SERVICE BULLETIN

CHECKING OR REPLACEMENT OF FLEXIBLE FUEL LINE FOR ROTAX® ENGINE TYPE 912 (SERIES) SB-912-054

MANDATORY

Fig. 1

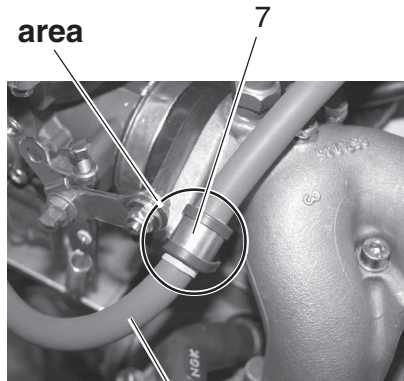
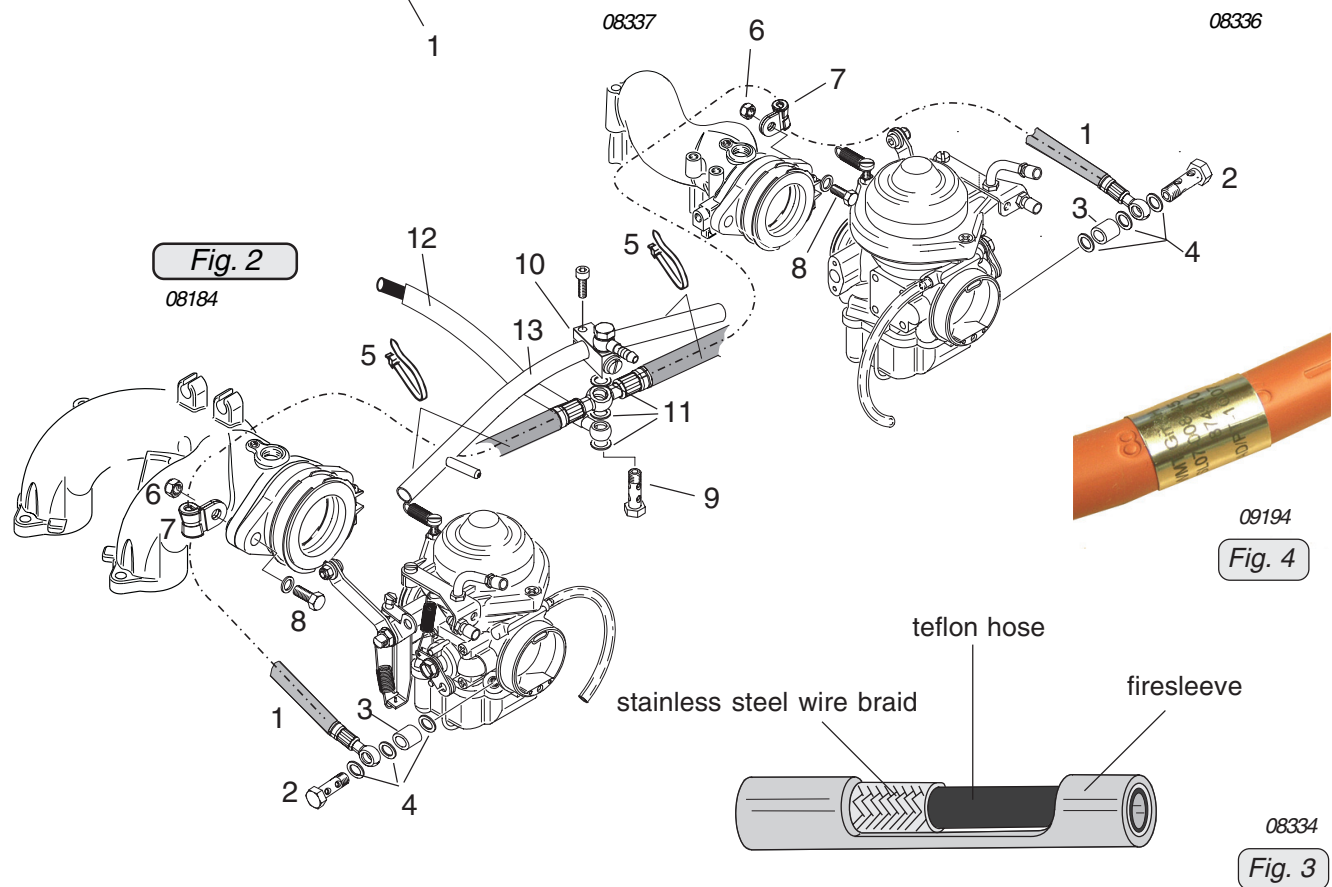
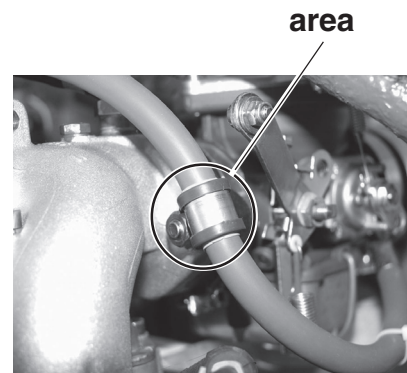
Due to a chemical reaction of the adhesive (in the area of the yellow position marks on the firesleeve) porosity and/or cracks on the firesleeve can occur.

Visual inspection of the fuel line (1) in the area clamp (7) and both ends of the yellow protection cover. (see Fig. 1)

◆ **NOTE:** A possible crack can be observed by careful bending of the fuel line. If you notice cracks or porosity then you need to replace the fuel line in accordance section 3.1.2.

1. Install flexible fuel line (1 and 12) and the banjo bolt (9) with new sealing ring (11) on the clamp block (10). Tightening torque of banjo bolt (9) 10 Nm (90 in.lb). Check that the fuel lines are not under strain or tension.

2. Install both cable clamp (7) in accordance with Fig.1 on the fuel line.

3. Install the fuel line (1) with distance sleeve (3) and sealing ring (4) on the carburetors. Tightening torque of banjo bolt (2) 10 Nm (90 in.lb). Place cable clamp (7) into position.

4. For proper support. Install the clamp (7) and hex. nut M8 (6) with LOCTITE 221. Tightening torque of hex. nut (6) 15 Nm (133 in.lb).
